Document Review Comment Sheet

PEB Ref. No : TB2-PEB-SDC-M1B-TVI-02734

DRAWING TITLE		HP FEEDWATER HEATER #6 11LAD10AC006/21LAD10AC006 DETAIL OF INSULATION SUPPORT						 SHEET 18/19	
VENDOR NAME		 WOORYANG HC CO., LTD			FUNCTION		NAME	SIGN	DATE
					DRWN		S.W.E.		24 FEB.2014
					CHKD		H.K.LEE		24 FEB.2014
					APPD		J.C.YOON		24 FEB.2014
					APPD		S.S.KIM		24 FEB.2014

FIG. UG-118 FORM OF STAMPING

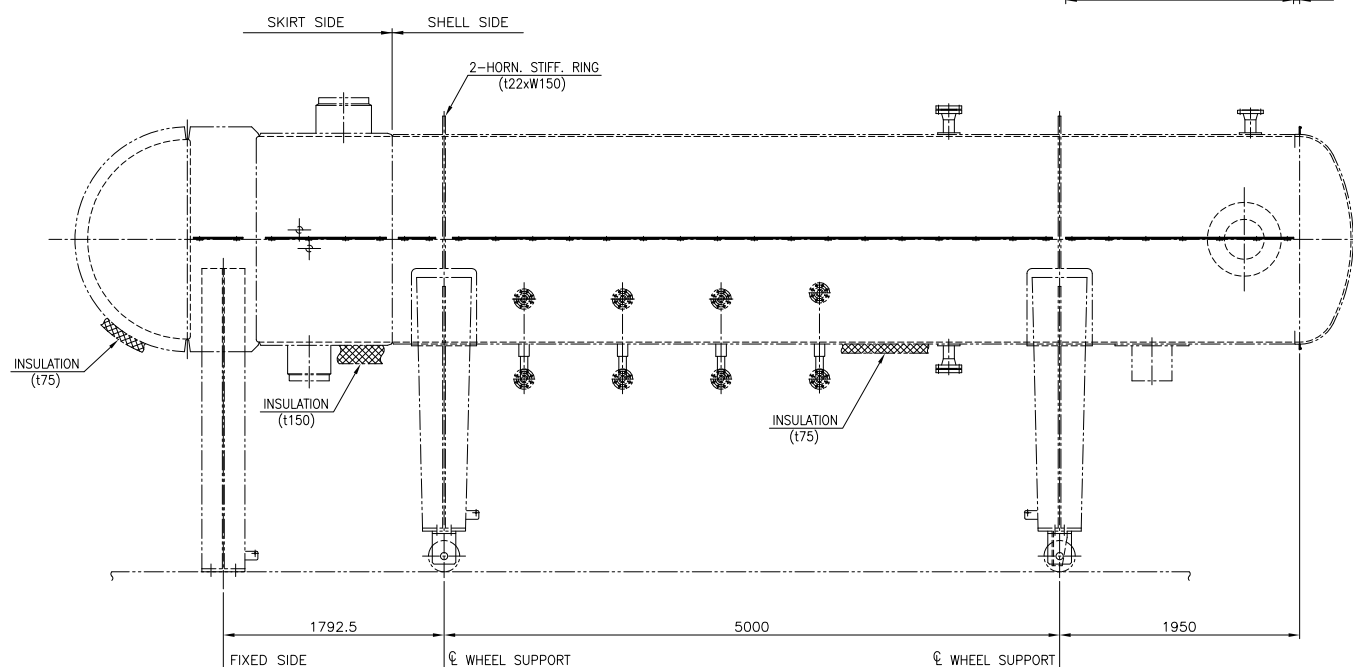
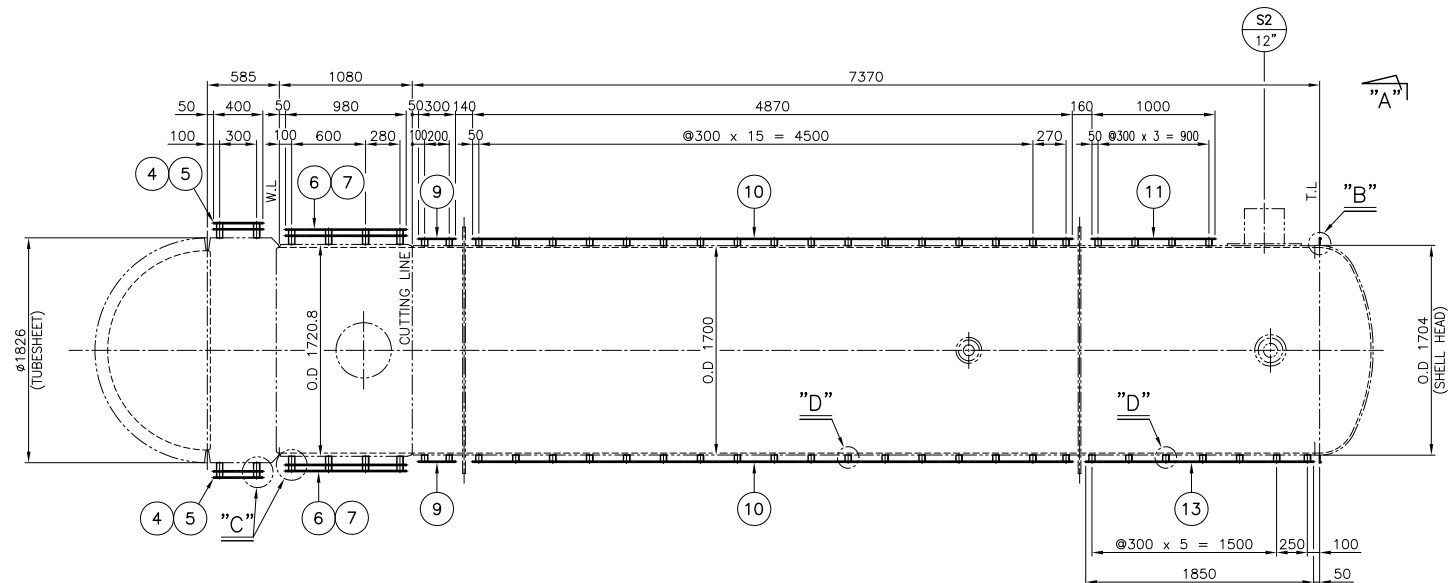
2	Please note that: Nameplates shall be in English with a minimum letter size of 6.4 mm.		ASME 'U'stamp project letter size was min 4mm.(UG-108). But we will used letter size 7mm.
